PLANNING COMMISSION REGULAR MEETING AGENDA

WEDNESDAY, MAY 10, 2017

The first submittal of the Manor Commons SE Commercial Concept (Concept Plan) submitted by ALM Engineering, Inc. and received on April 05, 2017, have been reviewed for compliance with the City of Manor Zoning Ordinance 263B.

The REVISED Manor SE Commercial Concept Plan submitted by ALM Engineering, Inc. and received by our office on May 1, 2017, has been reviewed for compliance with the City of Manor Subdivision Ordinance 263B.

Concept Plan

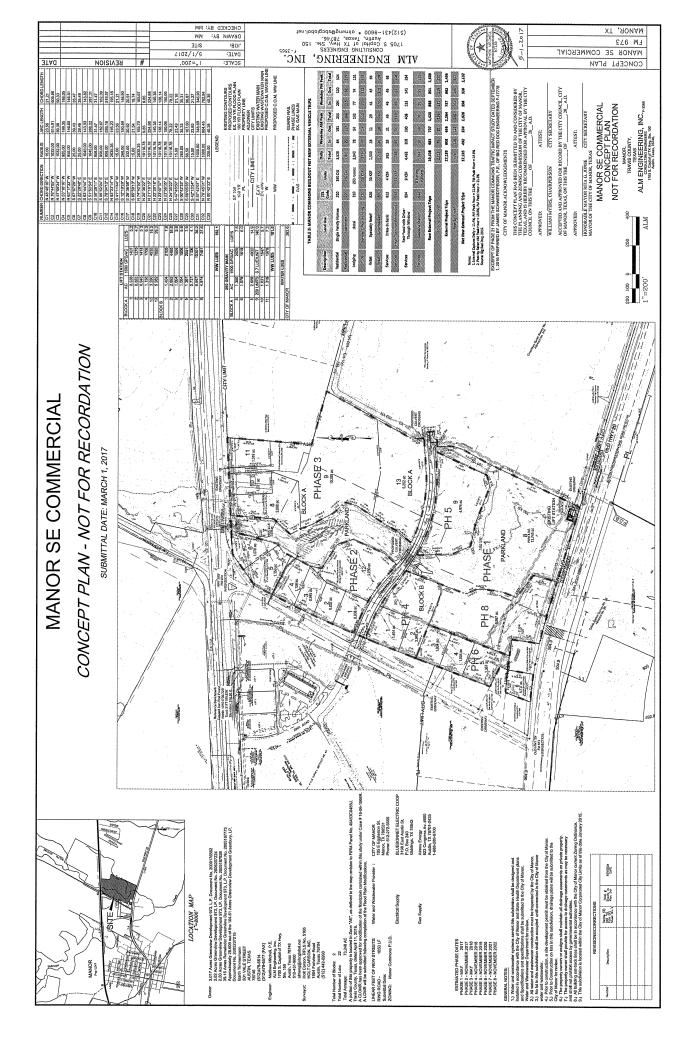
- 1. Section 21(c)(2) of Subdivision Ordinance 263B requires that the date the Concept Plan was prepared should be shown on the Concept Plan.
- 2. Signature blocks for Planning and Zoning and City Council should be added to the plan.

- 3. It is hard to distinguish between the different linetypes of the drawing. For example it is hard to tell the difference between the existing and new 100-yr. floodplain lines.

- 4. There are some lines that are not labeled.
- 5. Section 21(c)(12) of Subdivision Ordinance 263B requires that significant features on or within 200 feet of the property be clearly shown on the plans.

- 6. Section 21(c)(8)(i) and 21(c)(ii) of Subdivision Ordinance 263B require that the number of LUEs required for each category of lot be shown and the traffic volume to be generated by all proposed development other than single family be shown on the concept plan.

- 7. The summary letter submitted is for the proposed Preliminary Plan for the project, not the Concept Plan.

RESPONSE: The submittal date has been added to the top of the page.

RESPONSE: Added.

3. It is hard to distinguish between the different linetypes of the drawing. For example, it is hard to tell the difference between the existing and new 100-yr. floodplain lines. RESPONSE: See clarified linetypes.

RESPONSE: Lines information has been added to legend and some layers removed.

RESPONSE: Significant features have been labeled.

RESPONSE: The number of LUES have been shown on Concept along with estimated traffic based on an EXCERPT OF PAGE 21 FROM THE MANOR COMMONS TRAFFIC IMPACT STUDY DATED SEPTEMBER 1, 2016 PREPARED BY JAMES SCHWERDTFEGER, P.E., OF BIG RED DOG ENGINEERING F-17778

7. The summary letter submitted is for the proposed Preliminary Plan for the project, not the Concept Plan. RESPONSE: A concept plan summary letter has been provided.

FINAL PLAT OF MARQUEZ SUBDIVISION

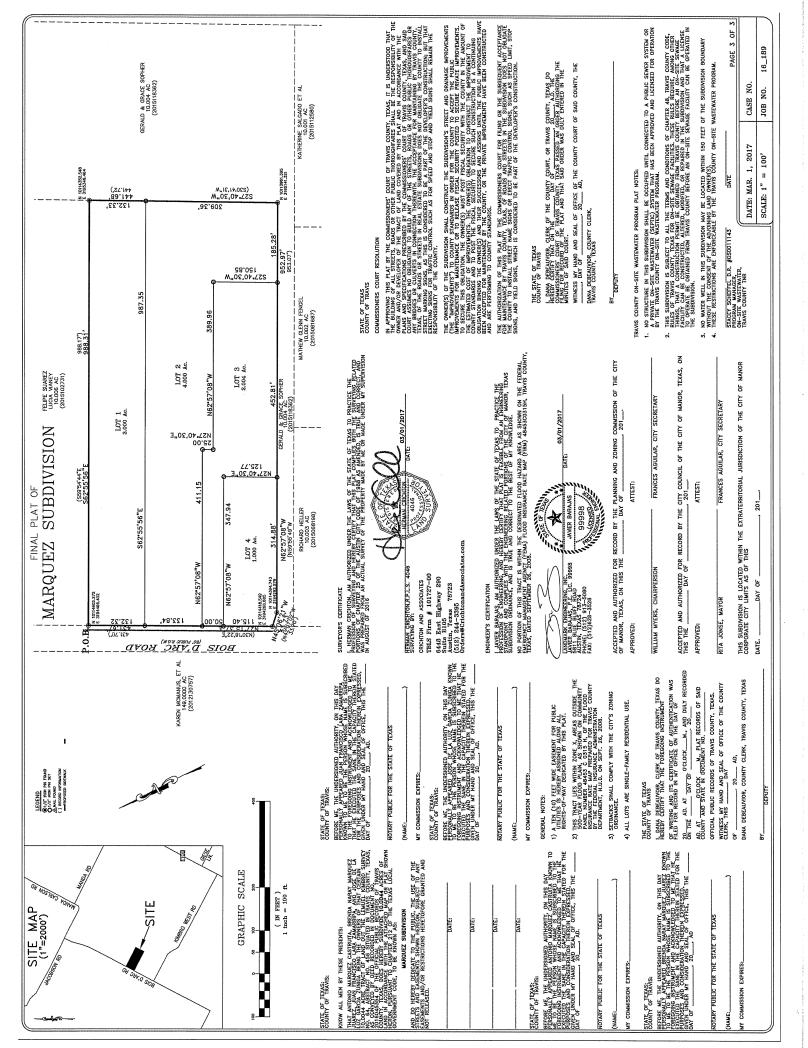
The engineer's certification has been provided as required by Section 24(c)(1)(vii) of Subdivision Ordinance 263B, but it is not the correct format. See the attached pdf for the correct certification note to use.

Certification from the County Health District is not provided as required by Section 24(c)(1)(viii) of Subdivision—Ordinance 263B. Certification from the County Health District that a subdivision is located in an area which cannot reasonably be served by an organized wastewater collection system and that the use of septic tank or other means of disposal has been approved by the County Health District. Said certificate shall show the limitations, if any, of such approval.

State Plane Coordinates are not provided on the plat as required by Section 24(c)(3)(i) of Subdivision Ordinance 263B. True bearings and distances to the nearest established street lines, official monuments, or existing subdivision corner which shall be accurately described on the plat and rotated to the state plane coordinate system. Using said system, X and Y coordinates shall be identified for four (4) property corners.

There are two different proposed subdivision names on the plat. The correct one should be shown.

The Planning and Zoning Chairperson should be listed as William Myers.

RESPONSE: The engineer's certification has been modified per PDF received.

RESPONSE: Marques Subdivision is the correct name for the subdivision. Plat has been revised and the correct name is depicted.

RESPONSE: Name has been updated.
